The latest planning applications at Cairngorm (2) – mountain bike trails and infrastructure

This post considers Cairngorm Mountain Scotland Ltd (CMSL)'s second planning application at Cairn Gorm, to create new mountain bike trails in lower Coire Cas. The application ([see here for planning papers](#)), as I will explain, is as poorly documented and thought through as the first, which was to create two new roads on the mountain ([see here](#)).

Mid-section showing the “Advanced Descent” Trail 07 (or should that be 007?). Note the proposed location of the snow factory and access road, which will presumably be subject of yet another planning application, and also the two pits to be excavated for trail construction material

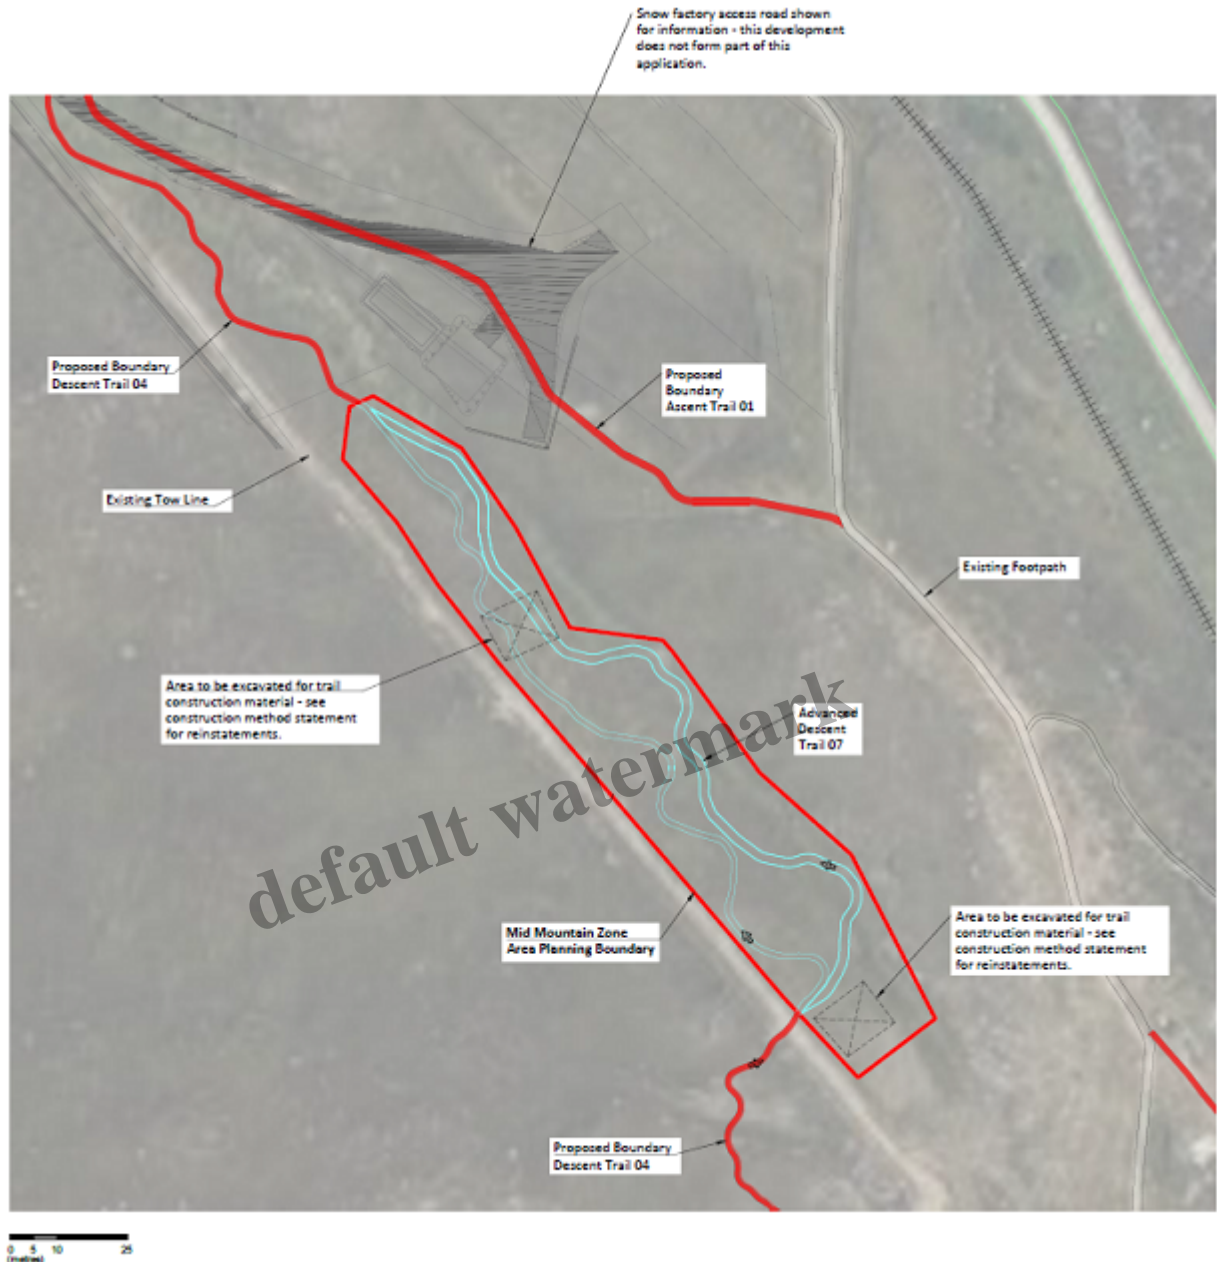
- there is no clear explanation of how the tracks will fit with existing snowsports infrastructure and the implications for this (indeed the primary purpose of the conveyor belt in the "learning zone" would appear to be for snowsports but there is no reference to that in the application);
- there is no explanation of the purpose or concept behind the "Ascent Trail" and why it has been split in Ascent Trail 1, 2 and 3 when it all appears part of the same route;
- there is no key to the colour coding used for the "Descent Trails" although it appears (but see below) to go brown, red, blue in ascending order of difficulty;
- if this interpretation is correct, someone wanting to cycle the "medium difficulty" red trail to the shieling and then back down could then get stranded as the two trails down the mid-zone are both blue and one is labelled as "Advanced Descent 07";

How the inclusion of an “Advanced Descent Trail” fits with the overall concept which is for a beginners’ mountain bike park, is not explained;

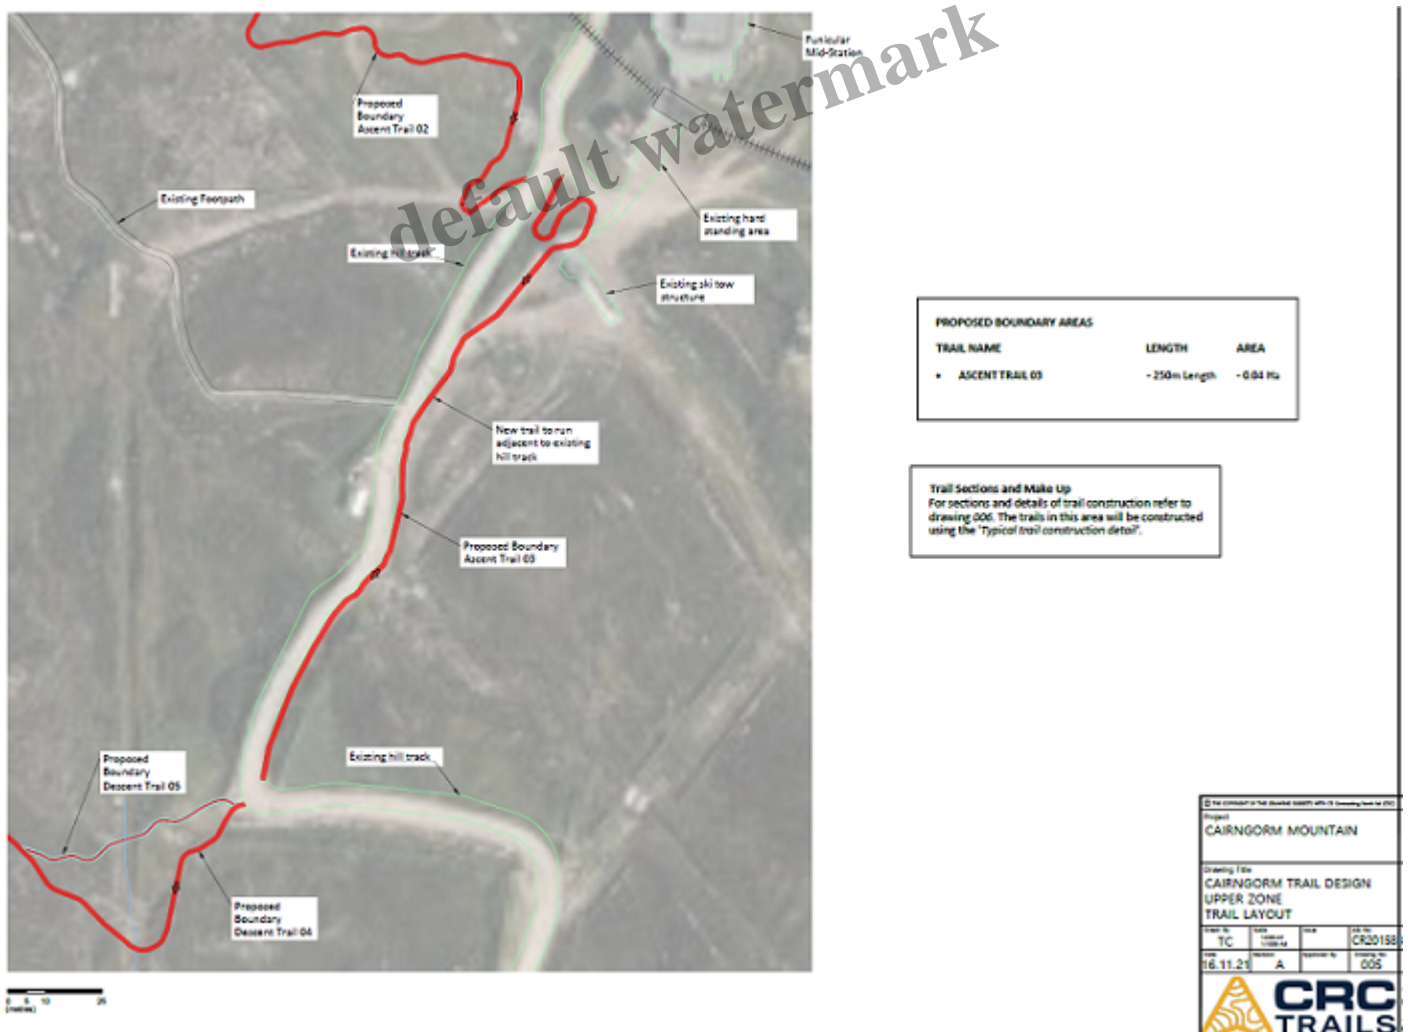
b) There is no ecological survey of the ground that will be affected although the “Covering Letter, Supporting Information” ([see here](#)) refers to an “Ecological Constraints Survey (Envirocentre November 2021)”. Perhaps the CNPA mistakenly forgot to upload the survey to the planning portal? The main supporting statement claims that “80% of the proposed bike park is on ground that has been manipulated by machinery during past skiing development”. The corollary of that 20%, ground in Coire Cas that has so far avoided being modified by human use, is going to be dug up for the first time while other parts are to be dug up all over again. There is no attempt to assess the impact of this on vegetation and slope stability ([see here](#)).?

View up the former ski tow onto Fiacaill Ridge, which will be crossed in two places (see top map) by the proposed mountain bike trails descending from the corner of the road (approximately where the snow fence on the left ends). The land on either side of the trench and banks created by the tow is generally unmodified and woodland has been slowly regenerating there.

The proposal is to add a mountain bike path along the upper side of this road. Photo August 2017

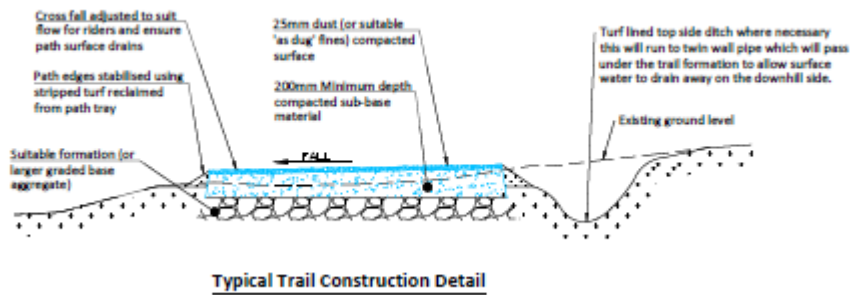
The proposal is that the top section of the ascent trail runs along the road up into Coire Cas the

landscape impact of which I considered in [The Cairngorms through the lens of Adam Watson \(3\) – Coire Cas, the long view](#). In effect CMSL is proposing to widen that road, which will increase its visual impact in summer.

Just why a new mountain track is needed here, when vehicles on the mountain are supposed to be kept to the minimum, or what it will add to the biking experience is not explained. The section diagrams for the track don't even explain its width:

At the very least it appears the footprint of the road, if this development was allowed to go ahead, would be widened by a further 2m, making it even more visible. Not what the National Park should be about.

View up the Shieling Track 2018

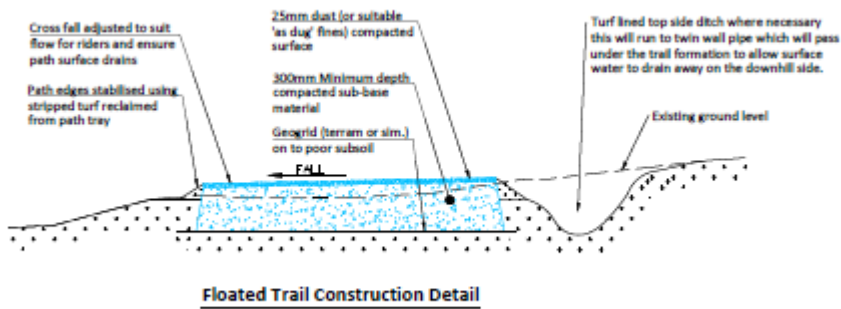
A second example. CMSL is proposing that Ascent Trail two (top map) will take a zig zag line up the ground between the Shieling Track and the snow fences and piste to the right. As you can see from the photo, the lower part of the proposed route is extremely boggy. That helps explain why one of the section drawings is for a “floating track”:

CMSL has made no attempt to assess what impact a floating track with drainage ditches will have on the peatland or what impact the zig zags will have on the landscape.

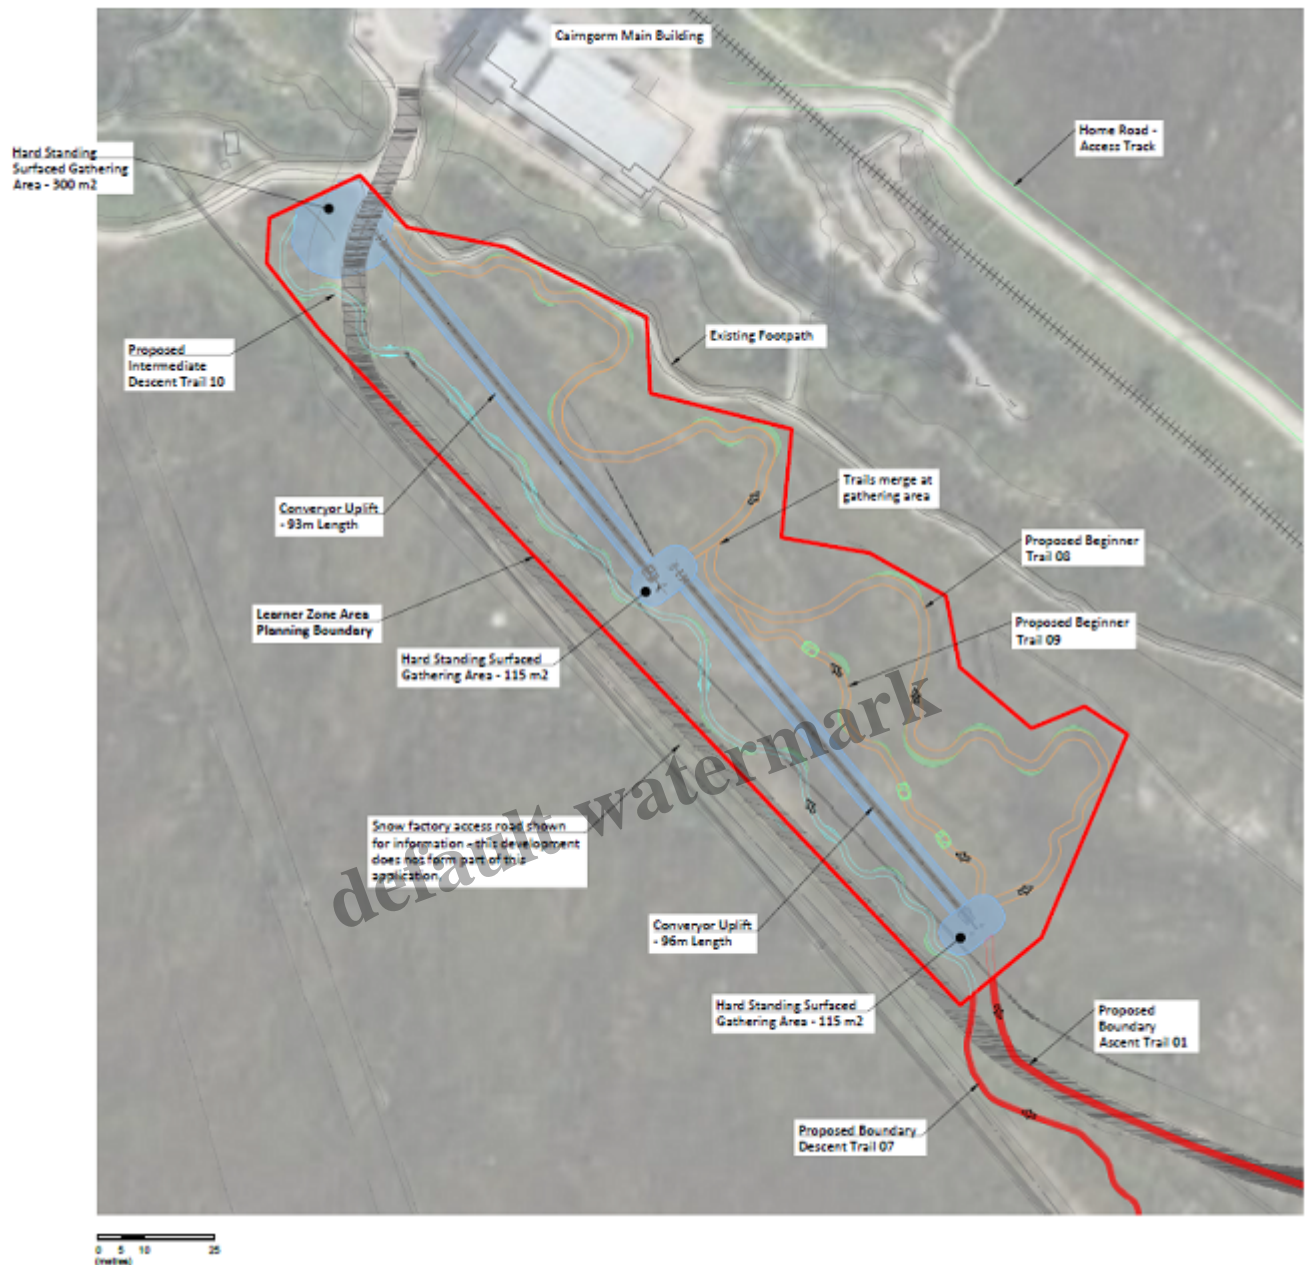
The impact of the learner zone in the area by the Day Lodge will be even greater:

In this plan the blue marks an “intermediate” trail whereas in the mid-section above blue means “advanced”! There is no key to the black shaded line which one might guess was a road but you will note that near the bottom of the map there are two parallel lines that run alongside it which are marked “snow factory road”.

There will be two conveyor belts – which as I have pointed out before should not be needed for bikes – with areas of hard standing at the top and bottom of each. Alongside the conveyor belt will be a new access road to the re-located snow factory, which CMSL says is not part of this application. It should be! The further development of this bit of ground by the Day Lodge should be considered as a whole, not piecemeal.
